RE: October 31, 2000 fax to Cubic Communications, Inc., Mr. Clive Winkler
FCC ID: NVSMTC-100TMCPA

Re: Application dated 10/11/00 and granted 10/31/00
Applicant Name: Cubic Communications Inc
Equipment Class: TNB-Licensed Non-Broadcast Station Transmitter
FCC ID: NVSMTC-100TMCPA

Under the authority of Section 1.113 of the Commission's Rules, the above referenced Grant of Equipment Authorization is hereby SET ASIDE.

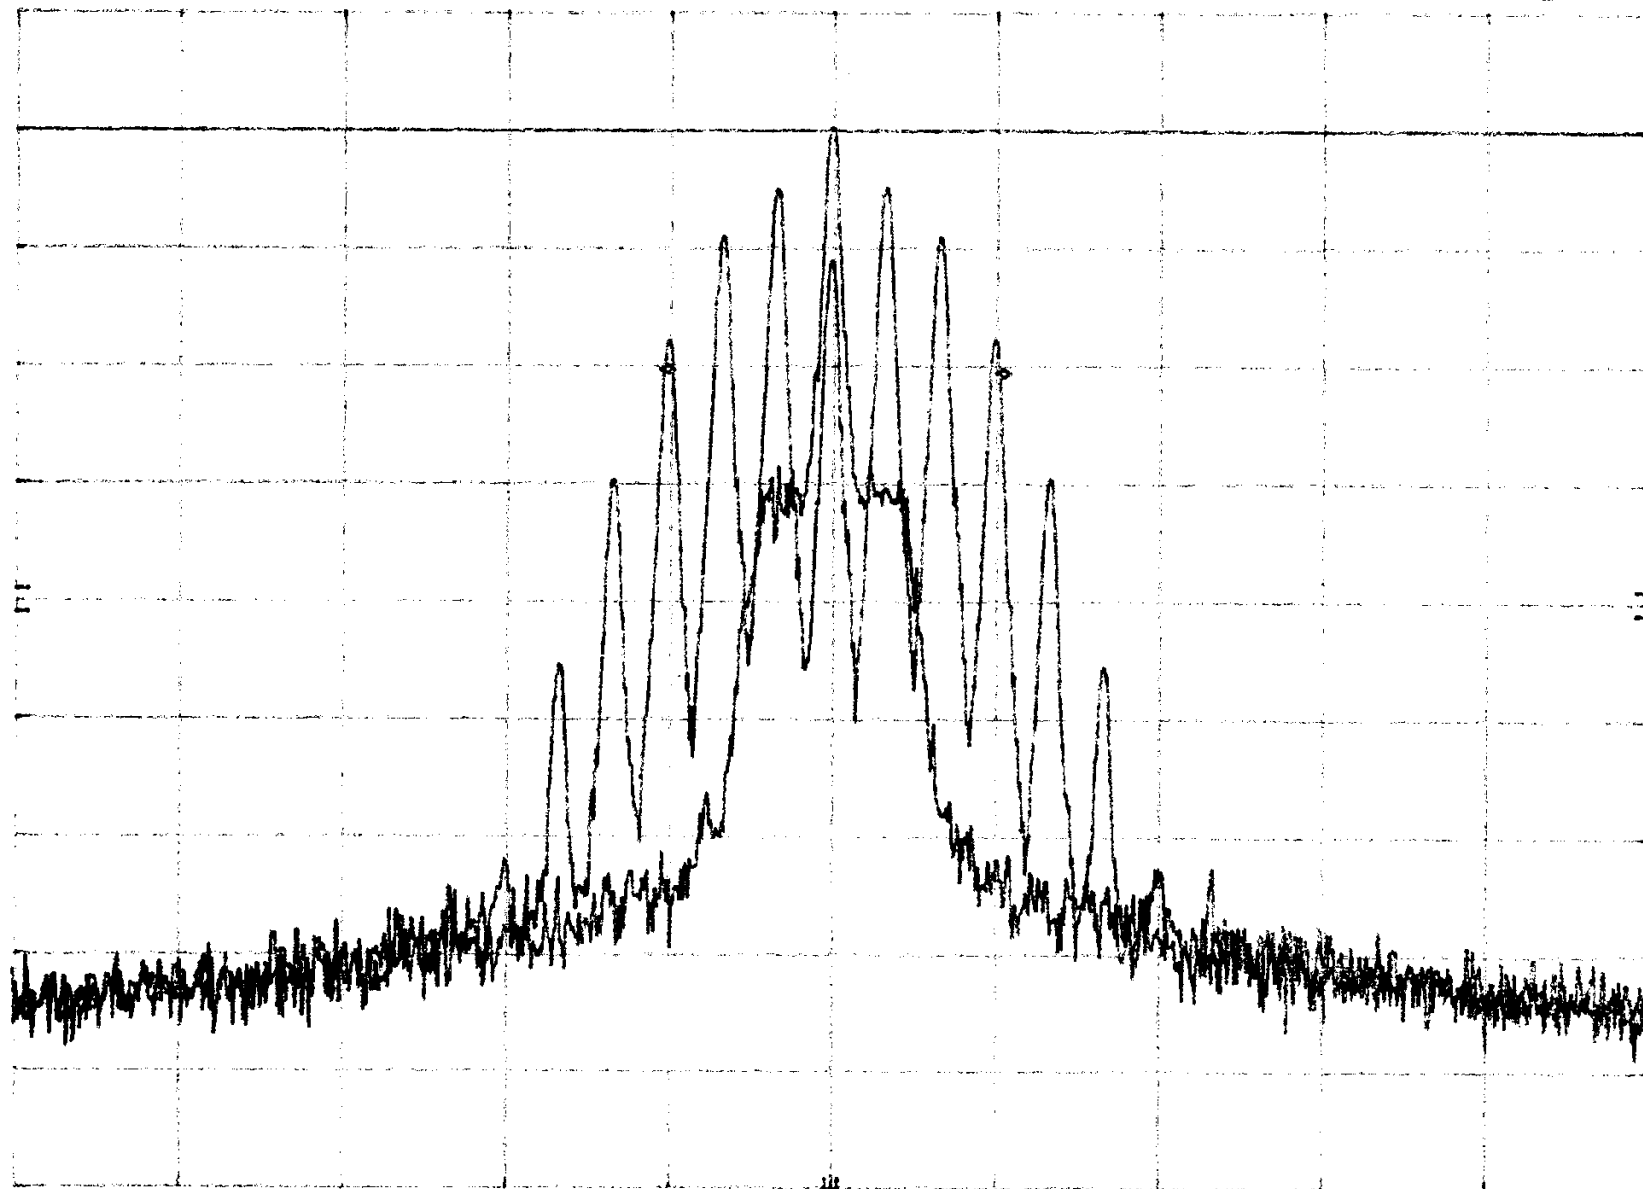
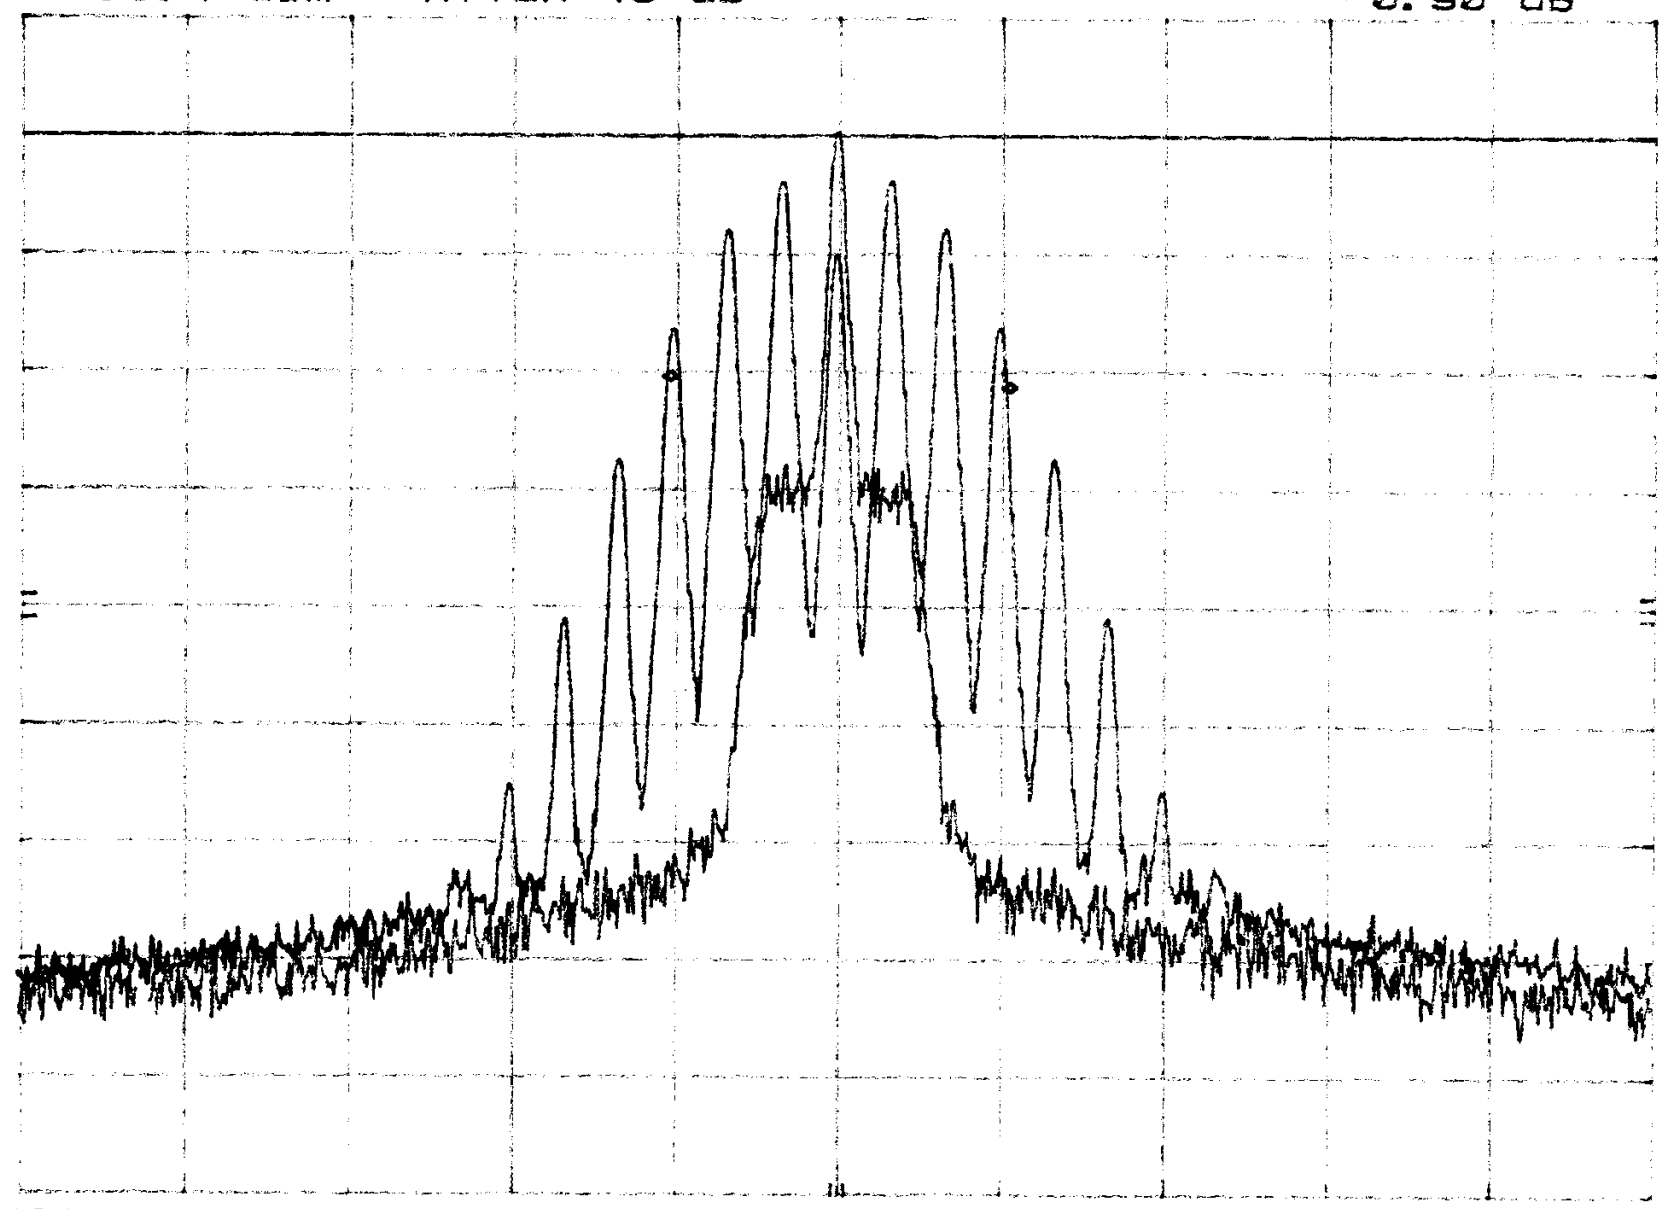
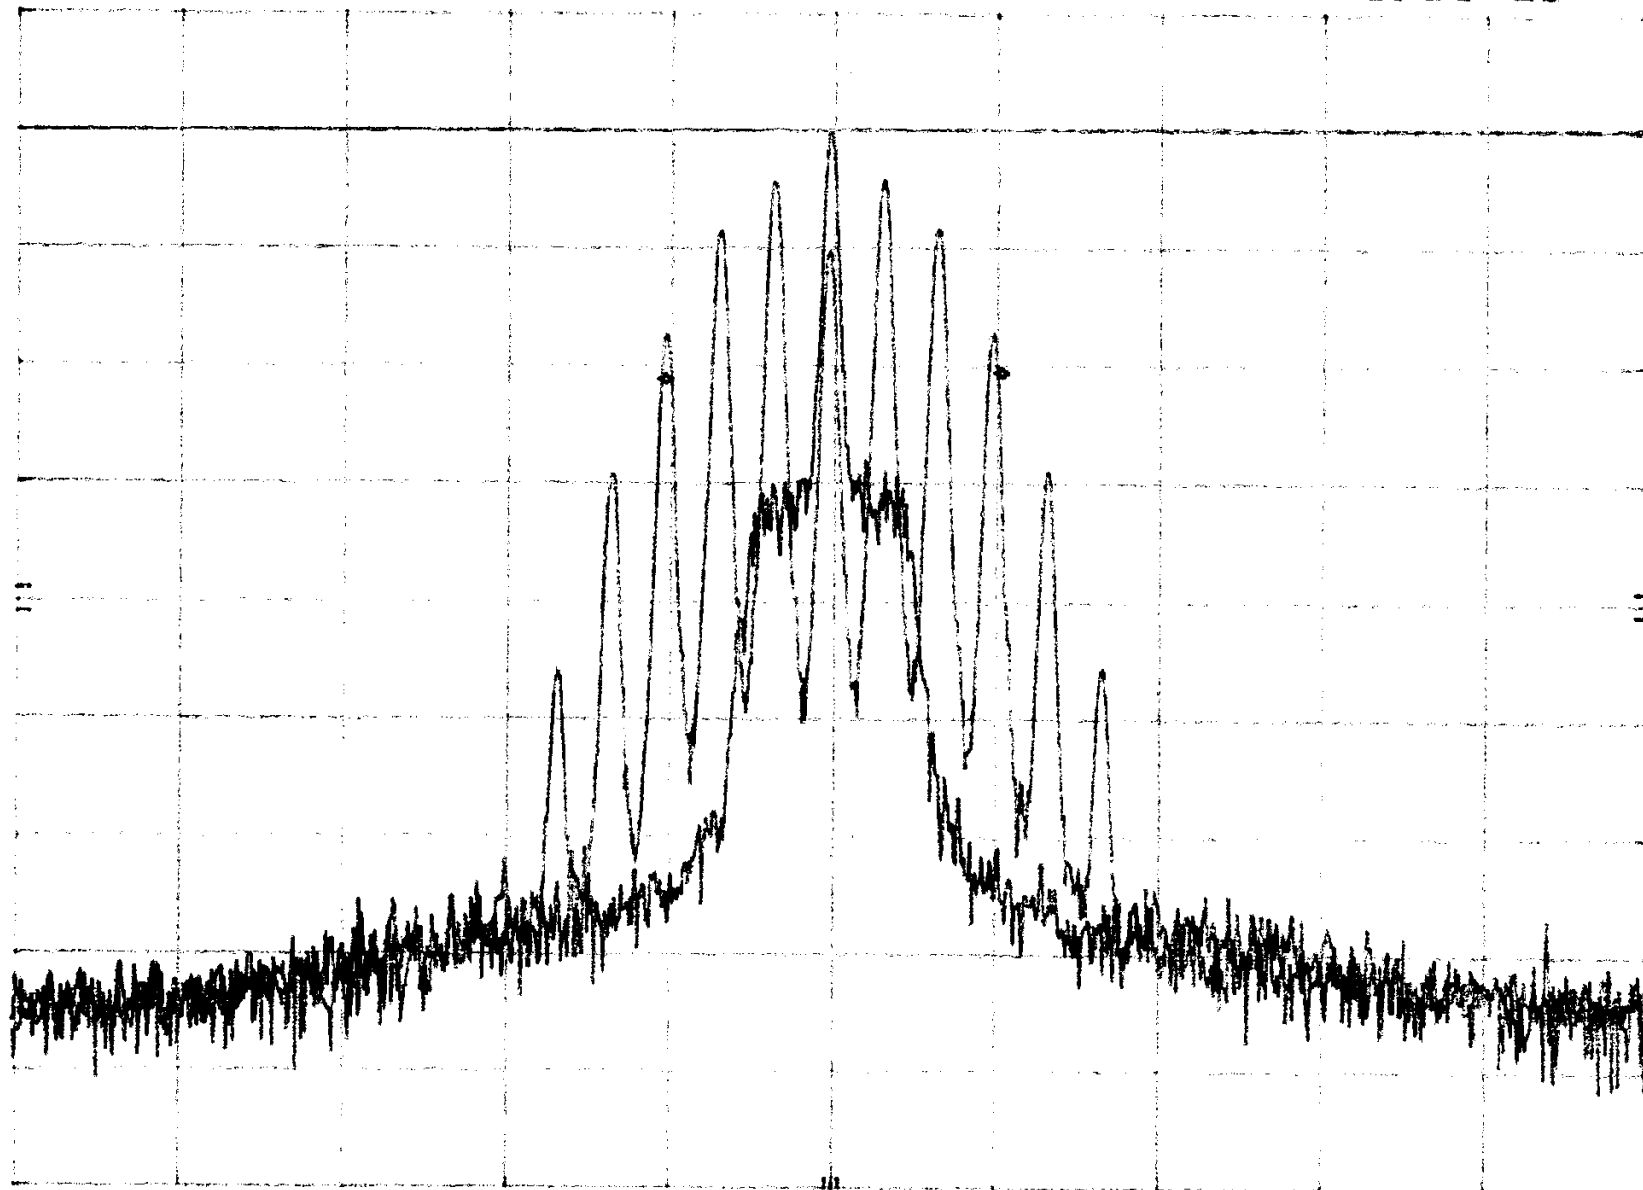
“The occupied bandwidth test was not made with the 2500 Hz tone prescribed by Section 2.1049 (c)(1) the Rules.”

We have attached measured data taken on 11/02/00 and 11-21-00 according to this specification. See pages 5 and 12 through 14
